Clyst Honiton Neighbourhood Plan Examination

Responses to Examiner's Clarification by Clyst Honiton Parish Council (as recommended and agreed with the Neighbourhood Plan Steering Group)

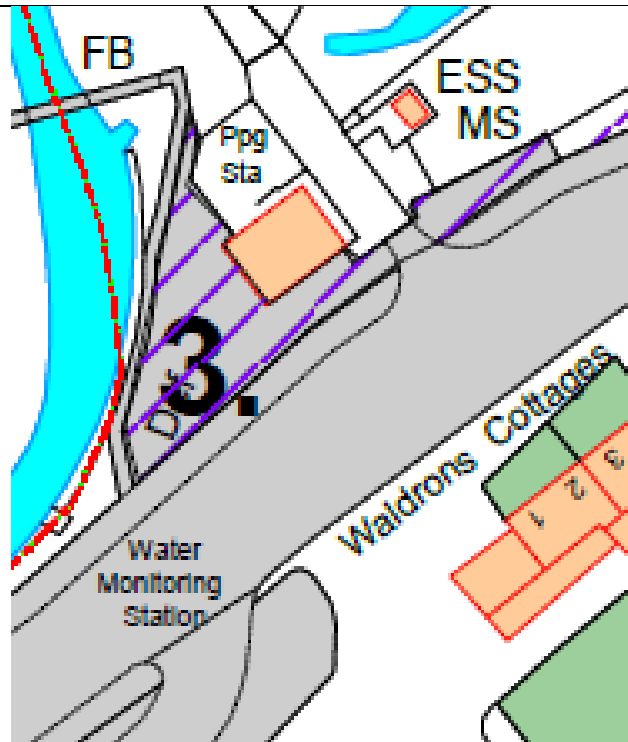
5	<p><u>Policy NE4: Local Green Spaces</u></p> <p>Three areas of verge are shown on Figure 50 on page 122 of the Plan with a fourth area partially shown. Please confirm which verges are proposed for inclusion. If the partially shown verge is proposed for inclusion, please provide me with a new plan showing the area in its entirety.</p>
	<p>EDDC is to provide a map showing the whole extent of Green Space 4. Ahead of the supply of a replacement map, for the Examiner’s information, this extract below from NPSG records shows the missing verge area 4 (labelled 3 on the map) in its entirety:</p>
